ENGINEERING CHANGE ORDER

BOARD NAME <u>CCD PreAmp Transition</u>	ECO# TRNT-034	DATE <u>19nov12</u>
BRD SERL# <u>027</u> REV _____	ART# <u>TRNT-EL-07-0007</u>	
PN# _____ REV _____	REV _____	
ASBLY# <u>TRNT-EL-04-0007</u> REV _____	PCB# <u>TRNT-EL-04-1007</u>	REV _____
BOM# <u>TRNT-EL-04-4007</u> REV _____	SCH# <u>TRNT-EL-04-2007</u>	REV _____
COGNIZANT ENGR _____	APPROVD _____

Figure 1 - Redesign with OPA1611 rev 1.1

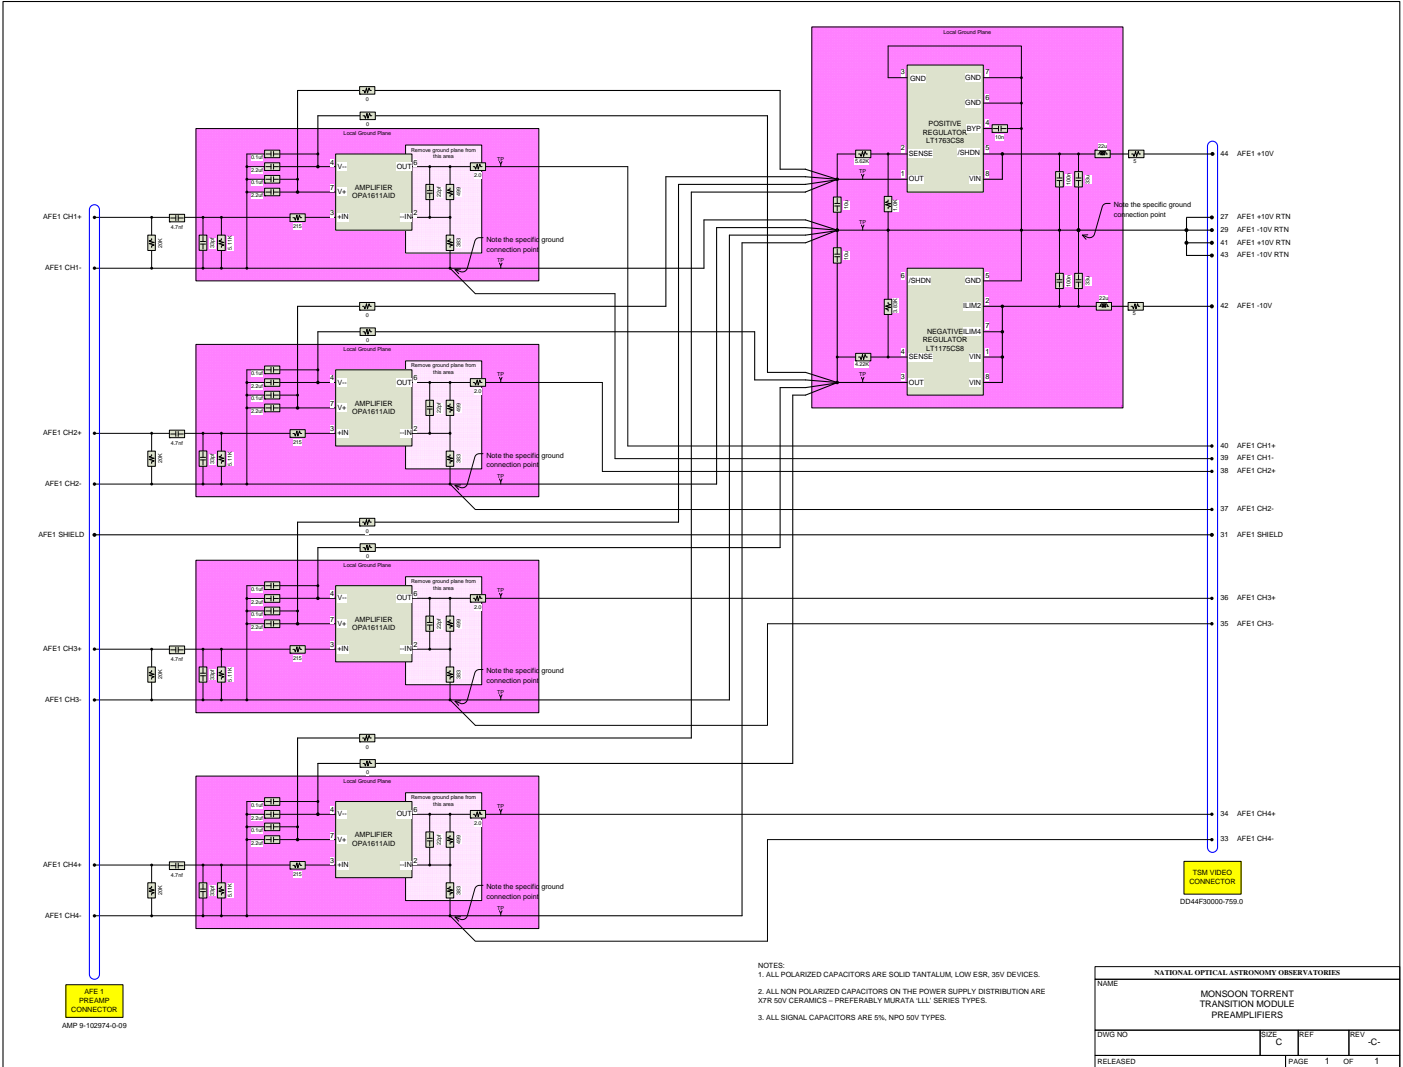
TRNT-EL-04-2007 (schematic) Use "Pre-amplifier Redesign with OPA1611 rev 1.1.pdf" to make modifications to optimize circuit and component values.
